CS North-South Cycle Route (Phase 2)

TfL Proposals (Rev 2B.1 / 2C)

Stage 1 Road Safety Audit

Ref: 2462.01/000/A201/TLRN/2016

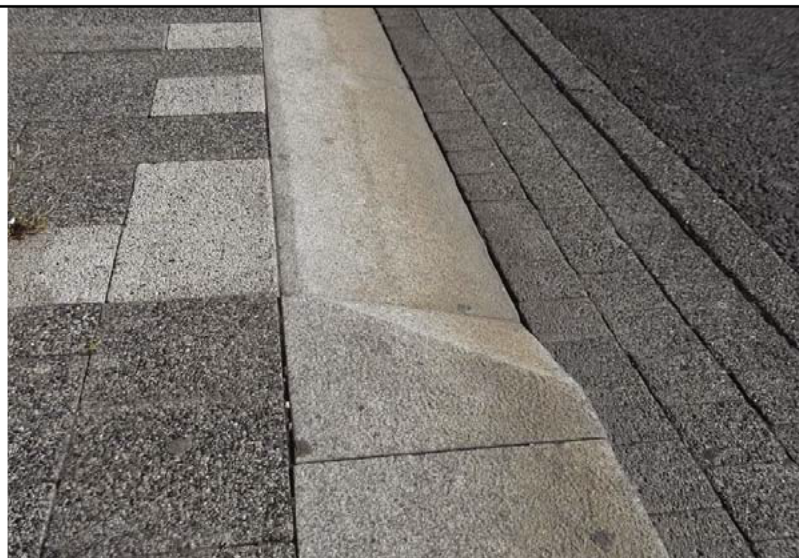
It is proposed to provide battered kerbs for powered two wheelers to cross the cycle track and access the parking bay. The Audit Team are concerned that riders of powered two wheeled vehicles may attempt to access the parking bay at an acute angle, and the presence of the battered kerb may destabilise the rider. An exacerbated potential for the rider to become unseated, with an associated potential for personal injury may exist as a result.

Provide a smoother transition for powered two wheelers to access the parking bay. This may require the provision of a conventional dropped kerb or other similar measure.

Design Organisation Response	Part-accepted
	<p>Part-accepted: The current proposals show an angled 300mm wide kerb with a 50mm upstand. The pre-consultation drawings proposed a 150mm wide half battered kerb which would have been more severe for P2W to cross. The use of 150mm wide kerbs was raised in audit Ref: 2462/VAR/A201/TLRN/2016 and the design was amended.</p> <p>Additionally the design team anticipate that P2W users will slow down before attempting to cross the kerbs as they will be turning across a cycle track into a parking bay where they will become stationary. The design team are concerned that too shallow a gradient could encourage P2W users to cross the track at a high speed reducing their visibility of oncoming cyclists. TfL's Motorcycle guidance document is not specific on appropriate gradients for P2W, however it states that a 1 in 5 gradient at a raised side road entry treatment 'can cause issues for motorcyclists'. However, it is anticipated that P2W would have to approach a side road entry treatments at a higher speed in order to continue their onward journey. Side road entry treatments are recommended at TLRN side road junctions as part of TfL's Streetscape Guidance.</p> <p>An example of the angled kerbs is shown in the image below. These have a gradient of 1 in 6 because the whole kerb is angled rather than just the edge battered. This type of solution will be recommended to the detailed designers.</p>

Dropping the kerb to a flush or very low upstand across the mouth of the motorcycle bays would reduce the physical separation between cyclists and general traffic lanes, potentially compromising the safety and effectiveness of the scheme. P2W users and other vehicles may be more likely to enter a cycle track with less physical separation when accessing the side roads or parking bays along Farringdon Street.

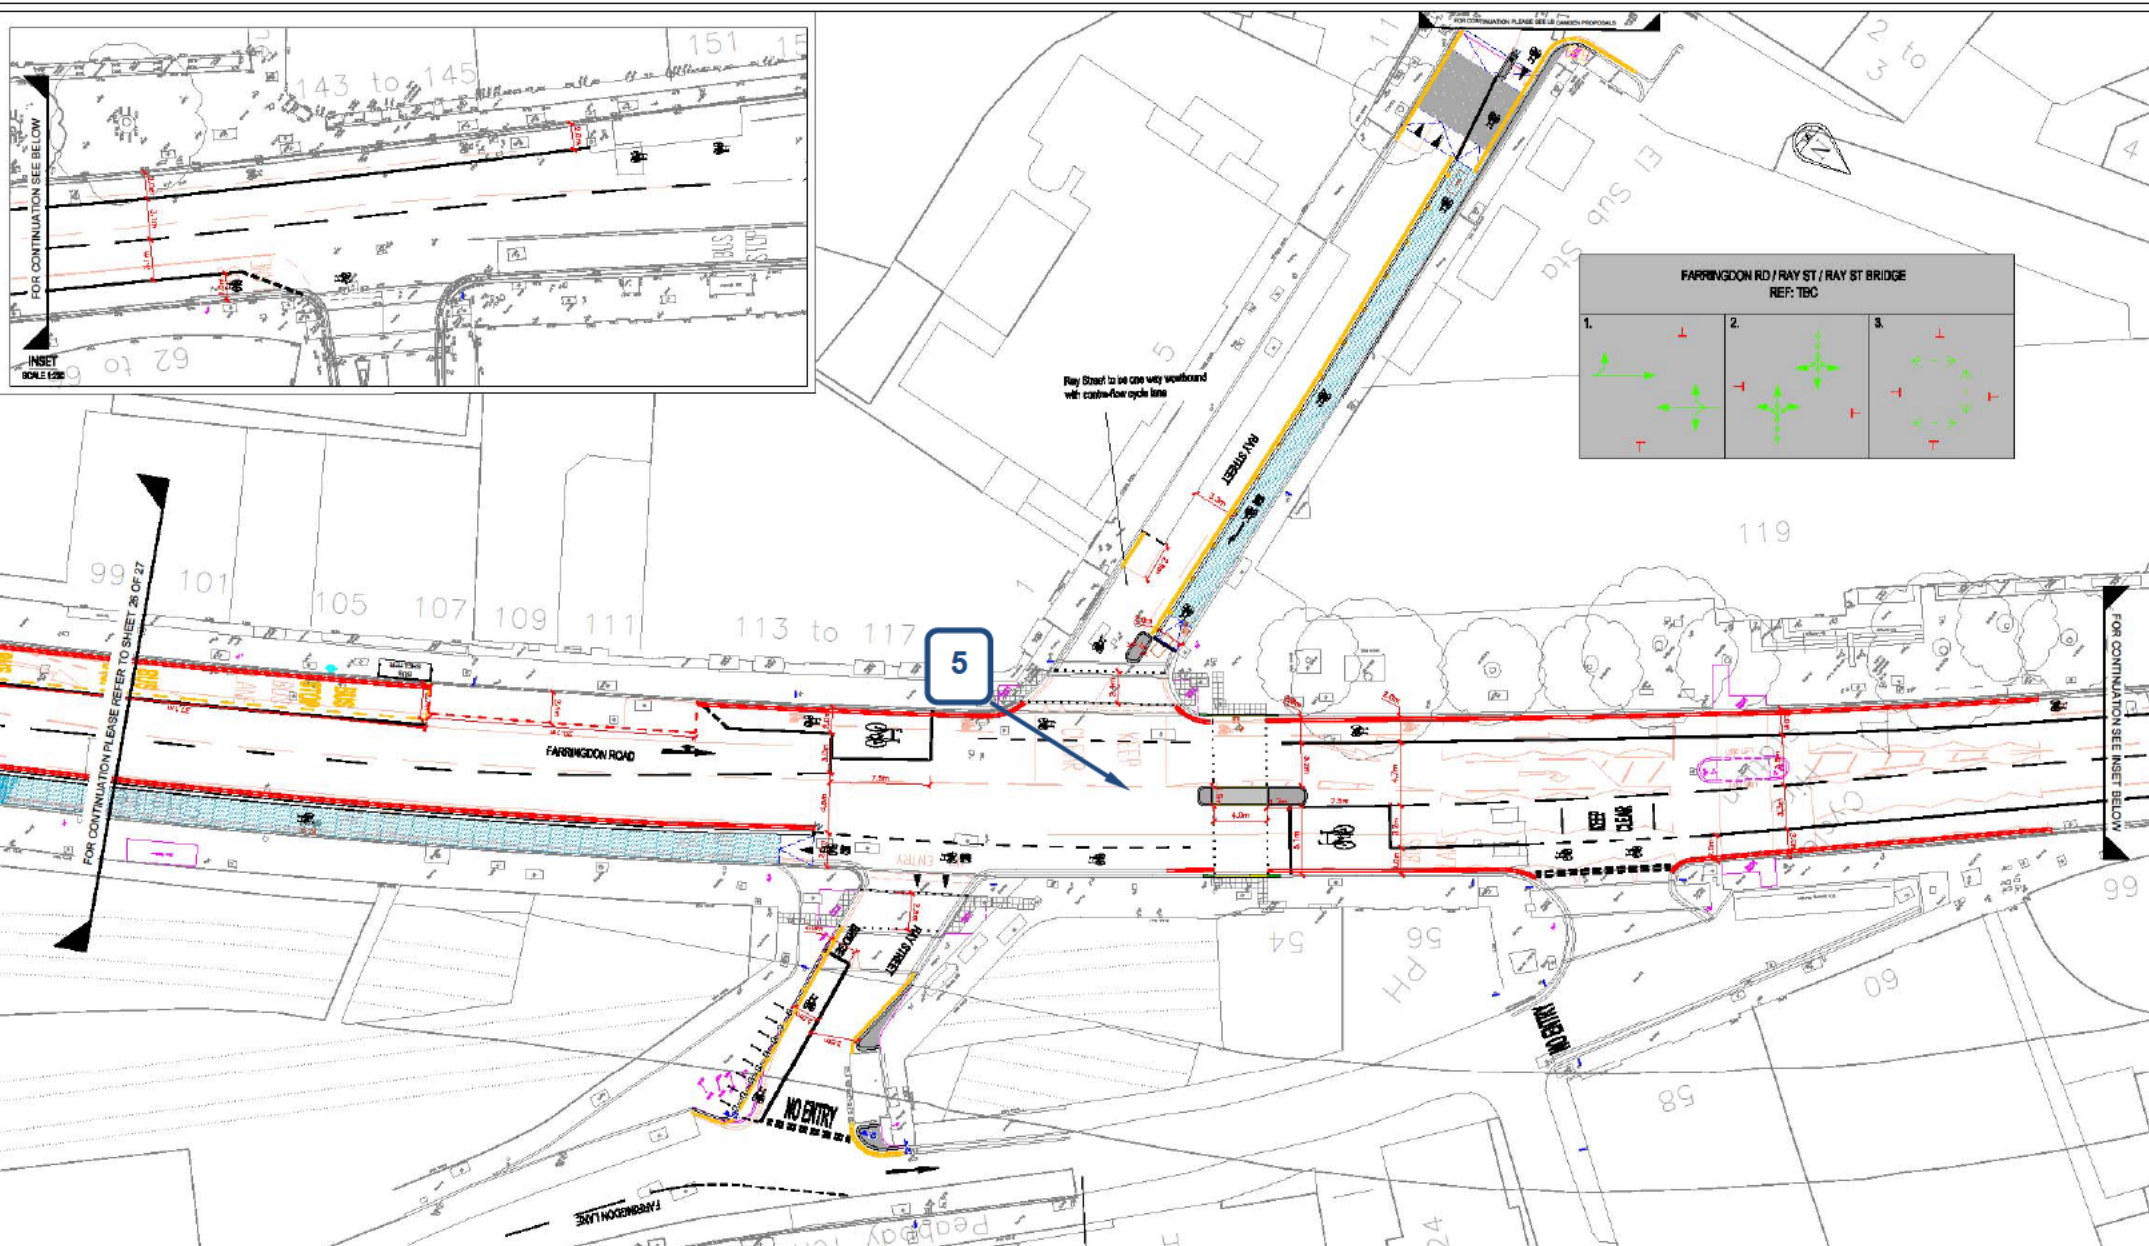
A previous iteration of the proposals included the provision of a right turn pocket for vehicles turning into Ray Street. The revised proposals remove this provision. It may be beneficial to provide a right turning pocket at this location to encourage correct road position and discourage encroachment into the opposing traffic lane.

Design Organisation Response	Accepted
Accepted: This was removed accidentally and has been reinstated into the designs.	
Client Organisation Comments	
Agree with the designer's response.
